The Lake Lothing (Lowestoft) Third Crossing Order 201[*]

Document SCC/LLTC/EX/51: Applicant's Responses to Written Representations and Interested Parties Responses to Written Questions

PINS Reference Number: TR010023

Date: January 2019

Figure A-1 Extract from APP-018 - 2.3 Land Plans (Sheet 2 of 5)

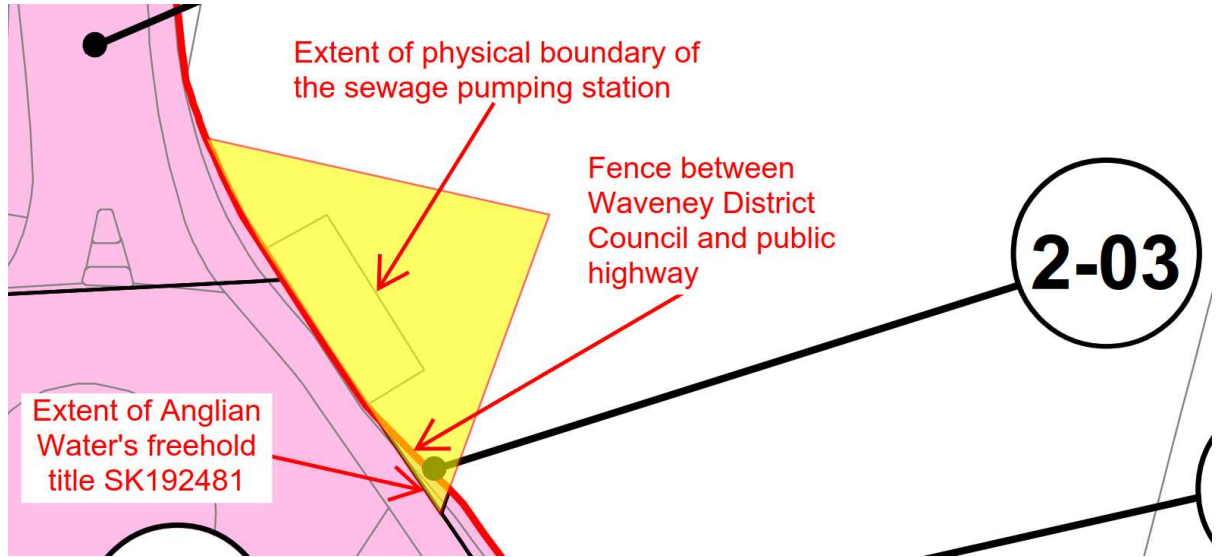
4.1-4.3	<p>Acquisition of land in Anglian Water's ownership</p> <p>Anglian Water questioned about the Application which proposes to permanently acquire land in Anglian Water's ownership as identified on the submitted land plan (document APP-18). There appears to be an existing inline sewage pumping station (Lowestoft Road-Denmark Road SP) in Anglian Water's ownership located immediately adjacent or within the boundary</p>	<p>There is a discrepancy between the extent of the boundary of Anglian Water's freehold title, SK192481, and the physical boundary of the sewage pumping station on the ground.</p> <p>The excerpt in Appendix A taken from APP-018 - 2.3 Land Plans (Sheet 2 of 5) shows the extent of title SK192481 (highlighted in yellow). The footprint of the sewage</p>

Reference	Extract	Applicant's response
	<p>of parcel 02-03. Similarly there are existing foul sewers located within the parcels identified as being within Anglian Water's ownership (parcels 02-02, 02-03 and 02-05).</p> <p>Anglian Water states it has not had specific discussions about the implications of permanent possession of land in Anglian Water's ownership on the operation and maintenance of the existing assets as set out above.</p>	<p>pumping station is smaller than the extent of the freehold title, part of which extends into the adjacent land holding of Waveney District Council and part into the public highway. Plot 2-03 on the Land Plans is part of the public highway (footway and verge adjacent to Denmark Road), within Anglian Water's freehold title, SK192481. As such the Book of Reference (application document APP-009; updated at Examination Deadline 4 with Document Reference SCC/LLTC/EX/55) lists Anglian Water as the owner of plot 2-03 (in respect of part of registered title), and also lists Suffolk County Council as owner and occupier (in respect of public highway). There will not be any impact on the sewage pumping station.</p> <p>Impacts are not expected to occur to the foul sewers located within this parcel, but they would in any event be protected pursuant to Anglian Water's Protective Provisions within the draft DCO.</p>

Figure 9 – Refined western option (OAR second sift) viewed from the west

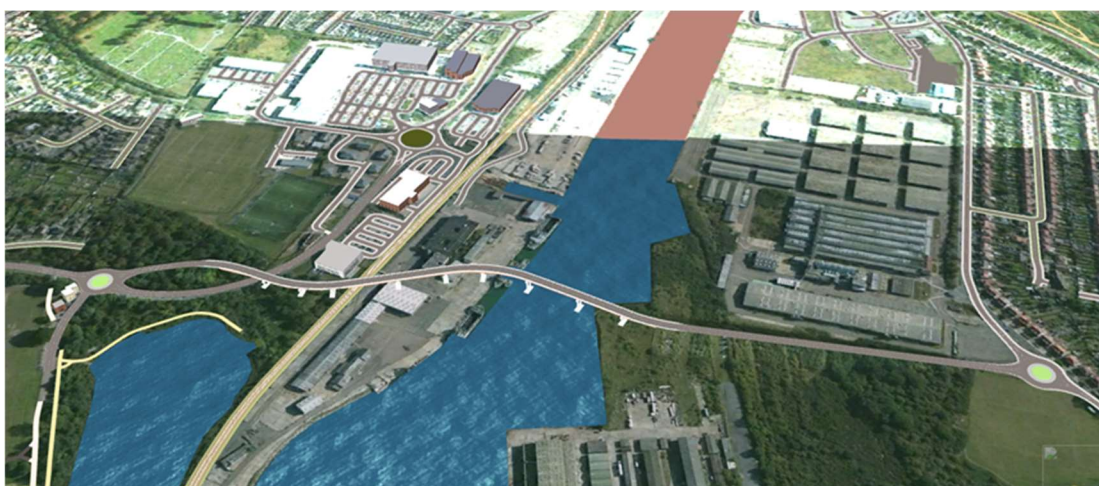
Written Rep Ref.	Summary / Extract	Applicant's Response
11.7-11.8	<p>Western Option</p> <p>ABP raised concern about the assessment of alternative routes for the crossing, in particular the reason for the Applicant rejecting a western option for the bridge. ABP stated if appropriately designed and located, this option would have been supported by ABP because it would not have detrimentally impeded port operations. In addition, ABP query whether the environmental effects of the proposed LLTC were properly considered in the context of the western option, bearing in mind the recent decision in Holohan (Brian Holohan and Others v An Bord Pleanala, (Case C-461/17).</p> <p>ABP state that the Applicant has promoted a line for the bridge that cuts through the middle of the operational Inner Harbour. The Applicant's proposal not only bisects the Port but, for the scheme to retain sufficient financial viability to justify the Government funding upon which the project depends – whilst contemplating an opening bridge, the Applicant also intends to retain total control of the periods when the bridge can be opened – in that the alternative</p>	<p>As explained in chapter 3 of the Environmental Statement (Document Reference 6.1, PINS Reference APP-136), the Applicant undertook a robust alternatives process before settling on the central option, including consideration of a western option.</p> <p>The Applicant has produced a note reviewing the western option in more detail, re-looking at that alternatives process in the context of the most up to date information, and concludes that it is still appropriate to conclude that the central option should be taken forward. This note can be found at Appendix B.</p> <p>With regard to the query relating to the 'Holohan' decision, the Applicant has prepared an updated Habitats Regulation Assessment (Document Reference SCC/LLTC/EX/42, PINS Reference REP3-038) which considers that case, and as with the HRA submitted with the application, concludes that there are no significant</p>

- 1.4.21. The refined western option (also referred to as W4) is illustrated in Figure 9 and described below.
- 1.4.22. The new road starts from a new roundabout on Peto Way, on the north side of Lake Lothing. It rises on an embankment, curving to the right and crossing Peto Way on a flyover. The bridge then curves to the left and crosses the railway line and waterfront obliquely, then curves again to the right to cross the lake. The central, lifting section is perpendicular to the main channel across a relatively narrow section of the lake.

- 1.4.23. The bridge is longer than had been envisaged in the first sift of preliminary options (W3) and the horizontal alignment involves an additional flyover at the junction with Peto Way and curves to minimise the impact on existing development north and south of the railway line. This arrangement enables the new road to gain sufficient height to clear the railway line with a gradient of than 5% and was considered the most satisfactory way of linking a western bridge option to Peto Way.

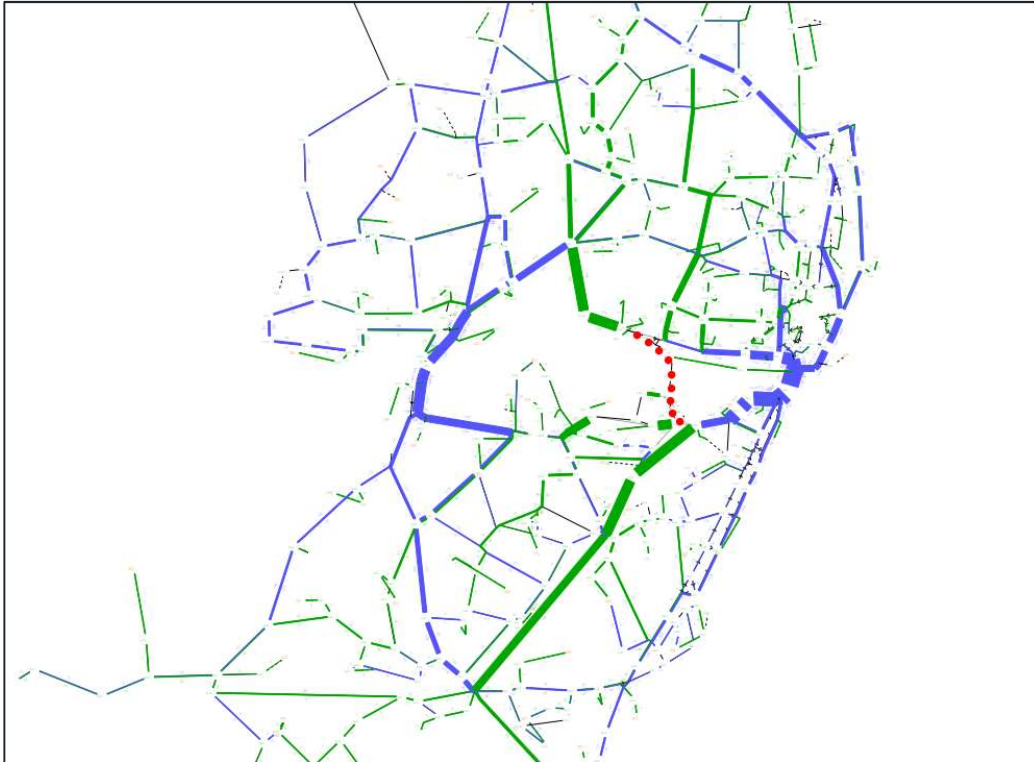
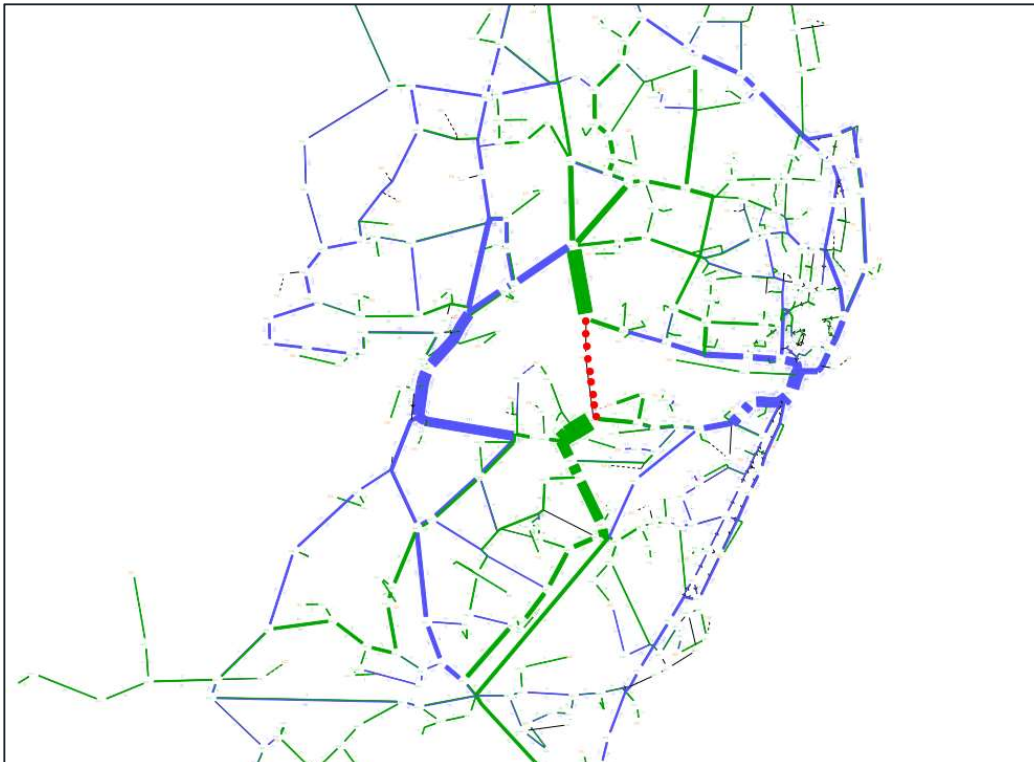
- 1.7.26. The different impacts of the Scheme and the suggested western option on the whole of Lowestoft's road network may be seen by comparing Figure 14 and Figure 15.

- 1.7.28. The bandwidth diagram for the central option illustrate the way the Scheme will encourage traffic to make use of the more modern, purpose-built roads, Peto Way and Tom Crisp Way. As a result, traffic levels around the A47 Bascule Bridge are generally reduced.

- 1.7.29. The bandwidth diagram for the western options shows how this option does not connect with the Tom Crisp Way in the south, instead drawing traffic through Kirkley Run and, to a lesser extent, Long Road, which runs parallel to the A12. Traffic levels around the Bascule Bridge are reduced, but not to such a great extent as with the Scheme.

INSET A - LOW LOADER
(ENTER SITE AND TURN TO EXIT)
(REFER TO KEY FOR VEHICLE PROFILE)

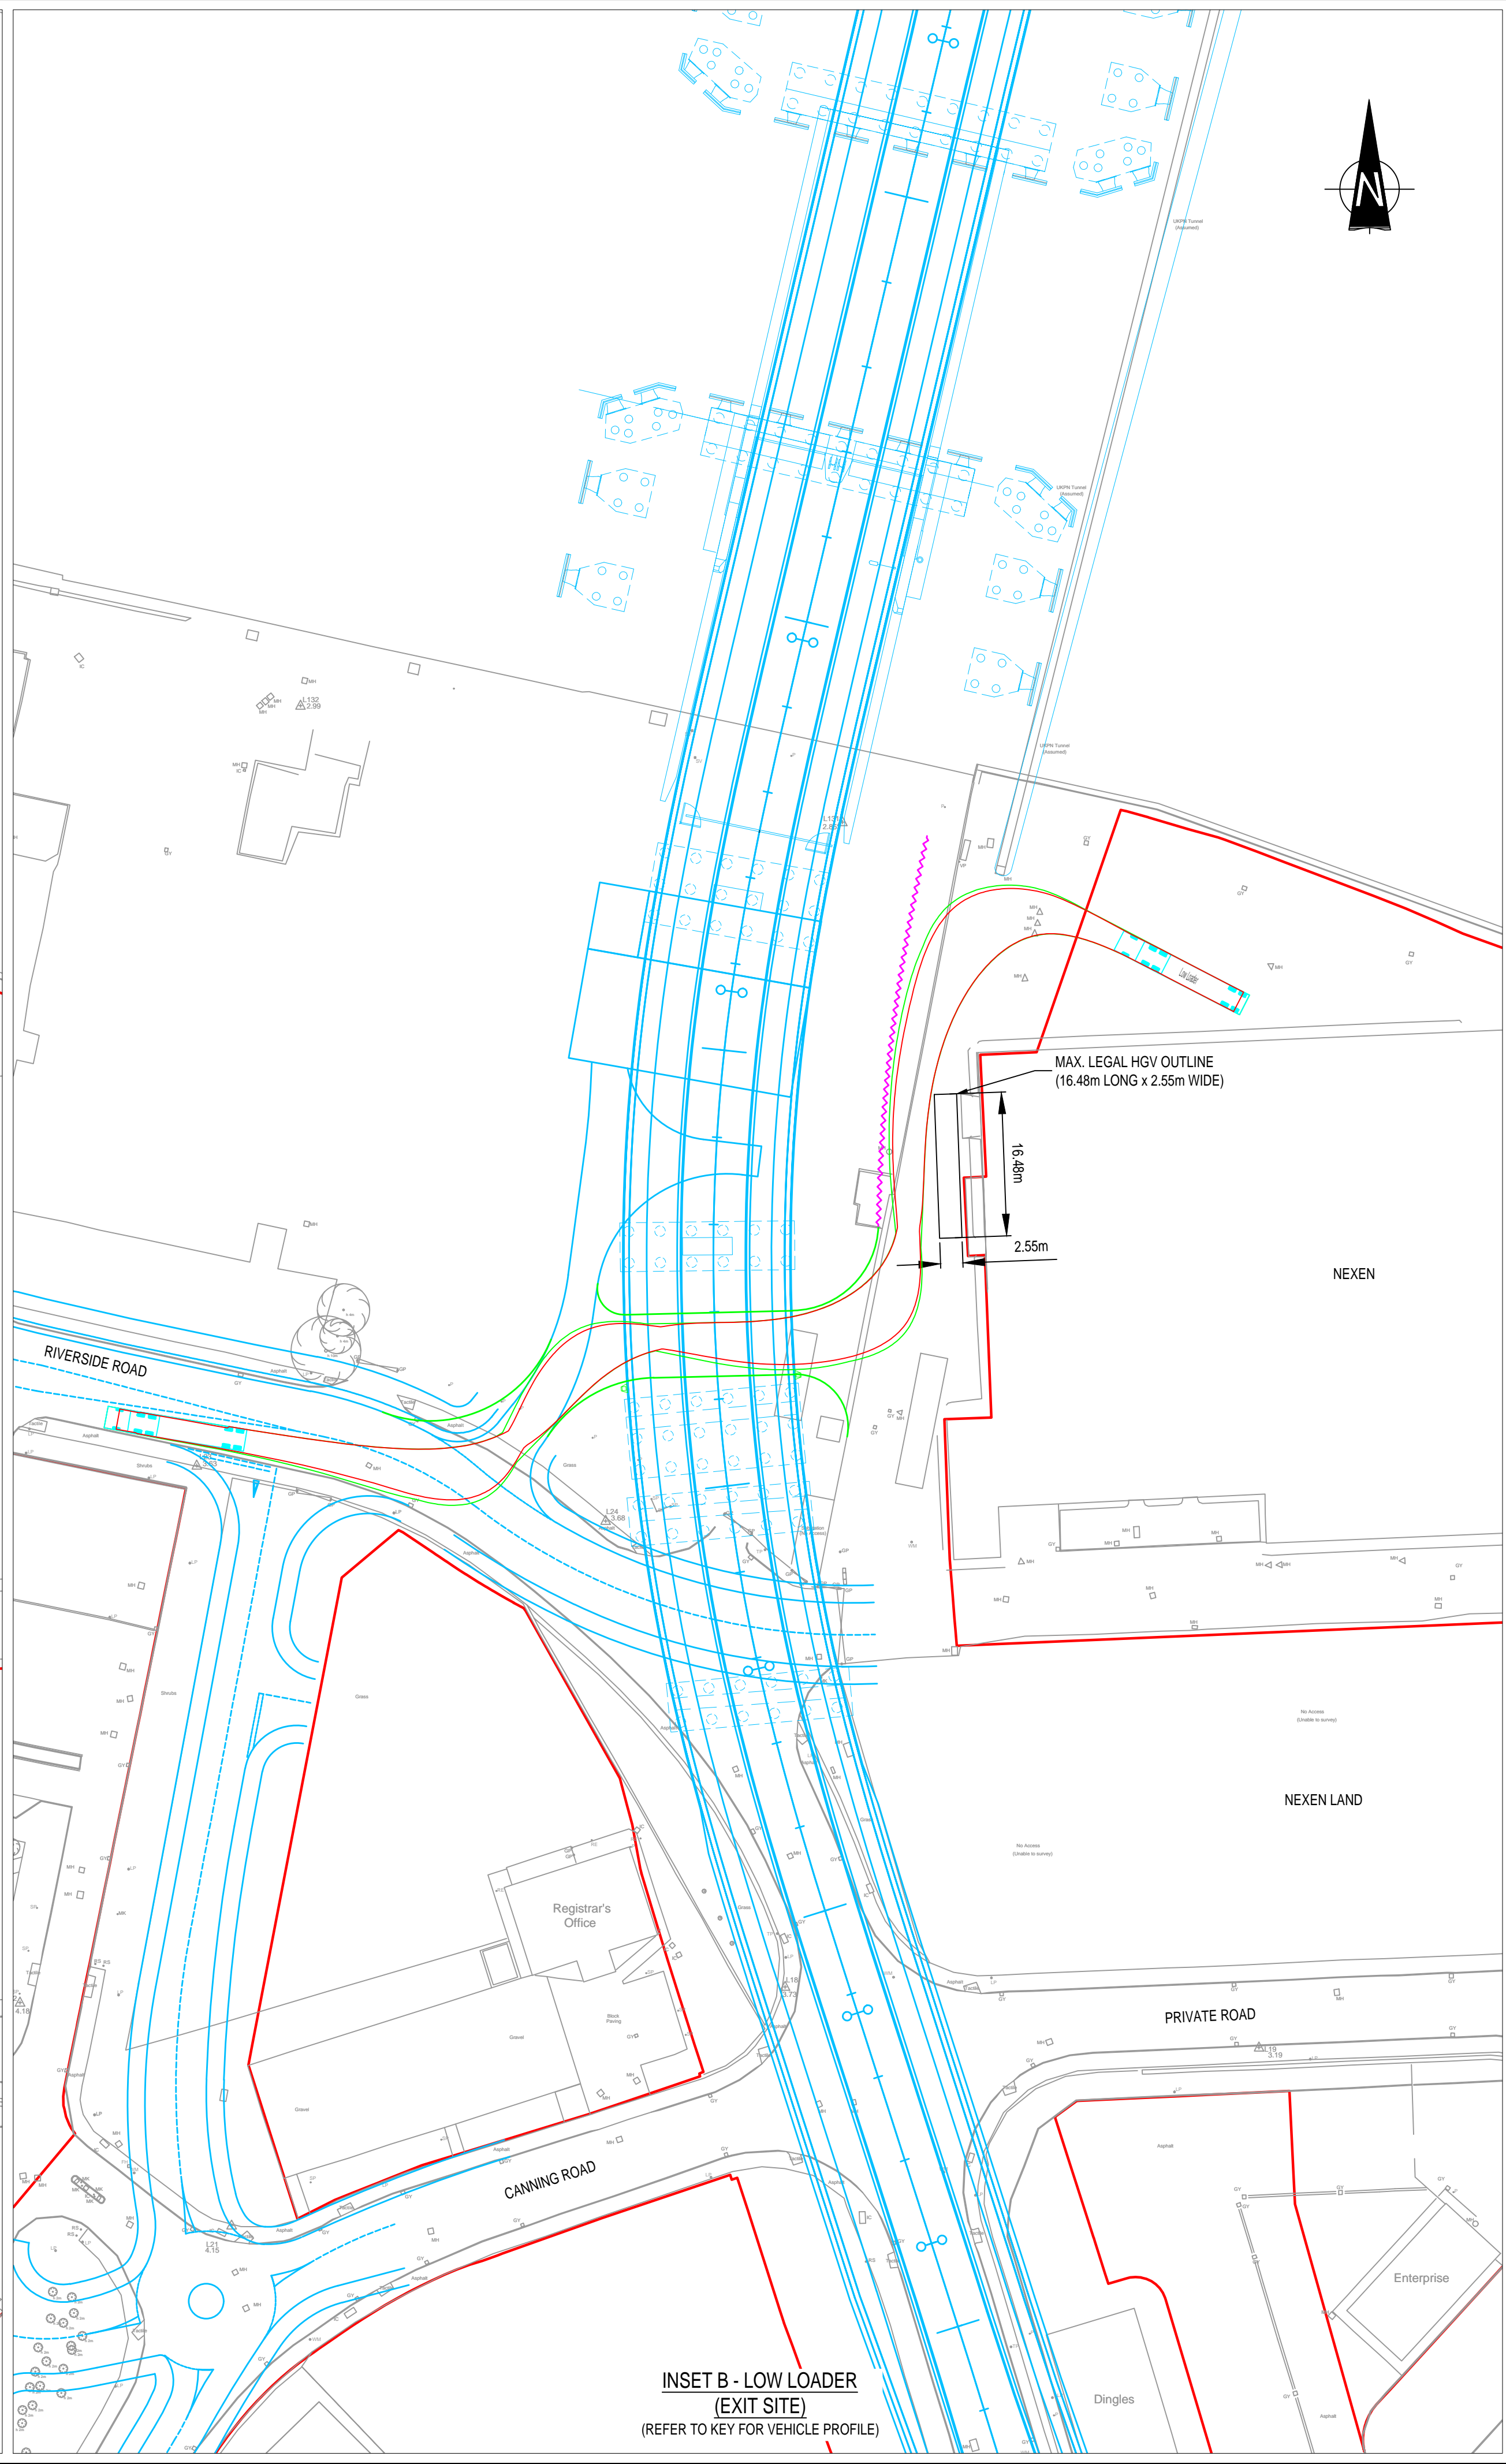
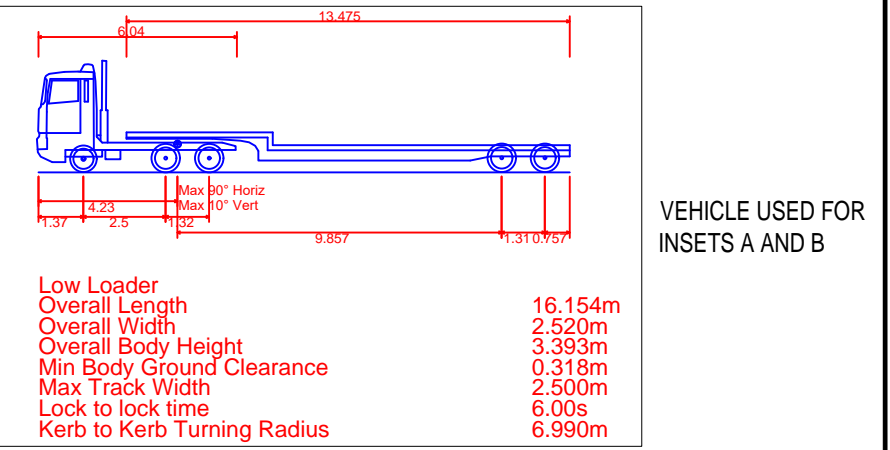
Paragraphs 13.8.4-13.8.5 in WR	<p>The alternative access arrangement proposals</p> <p>The Interested Parties state the alternative arrangement does not provide a new and separate access to the Development Land.</p> <p>They state the alternative remains unsuitable for the following reasons:</p>	<p>The Applicant's second access strategy provides an improved dedicated access point for the Interested Parties' main operational facility, freeing up the existing reconfigured access point to serve and be dedicated to the development Plot 3-56, should the Interested Parties choose to do so.</p> <p>The Applicant has provided further swept path analysis in respect of a newly designed second access strategy as shown in the Non-</p>

Reference	Extract	Applicant's Response
	<ul style="list-style-type: none"> The drawings setting out this alternative arrangement provide a swept path analysis for a low-loader vehicle entering the warehouse and factory part of the Land at two access points but this is based on an 18m long low-loader with trailer steering. This is not the type of vehicle used by our clients' businesses and a swept path analysis using a low-loader without trailer steering is required. Without such information the alternative arrangement proposals are technically flawed. The Applicant has not provided a swept path analysis for usual HGVs or for vehicles entering or leaving the Land when a HGV is being unloaded at the "goods inward" door to the west of the existing buildings. However, it appears from drawing 1069948-SCC-HGN-LL-DR-KK-0008 that such a vehicle could only enter or leave the Land when another vehicle is already at the "goods inward" door. The current layout of the Land does allow for one HGV to pass another HGV parked at the "goods inward" door. The alternative arrangement would only allow use of the new proposed additional northern access when the "goods inward" door was not in 	<p>Material Changes Application submitted at Deadline 4 (Document Reference SCC/LLTC/EX/69) that takes into consideration the Interested Parties' concerns and all types of vehicles confirmed as being used by the Interested Parties. The analysis addresses concerns raised by the Interested Parties, notwithstanding, the Interested Parties' delay in sharing with the Applicant their representative's analysis of the Applicant's opening proposals. This is the subject of ongoing discussion.</p> <p>As confirmed above, the Applicant has reassured the Interested Parties that access to their main site will be maintained and available during both construction and operation of the scheme (on the basis outlined above) from the public highway, without any reliance on access over a third party's land. Clearly, acceptance by the Examining Authority of the proposed non-material change to the Application, which seeks to provide a second access for the Nexen site, would assist the Applicant in delivering this commitment to the Interested Parties.</p> <p>The Applicant has provided traffic management and vehicular tracking information to demonstrate that current vehicle movements could continue to be made within the site post-implementation of the Scheme. The Applicant also advises that the interim CoCP (Document Reference SCC/LLTC/EX/61) imposes a requirement on the Contractor to maintain access to Nexen's site during the construction phase (paragraph 2.7.1).</p>
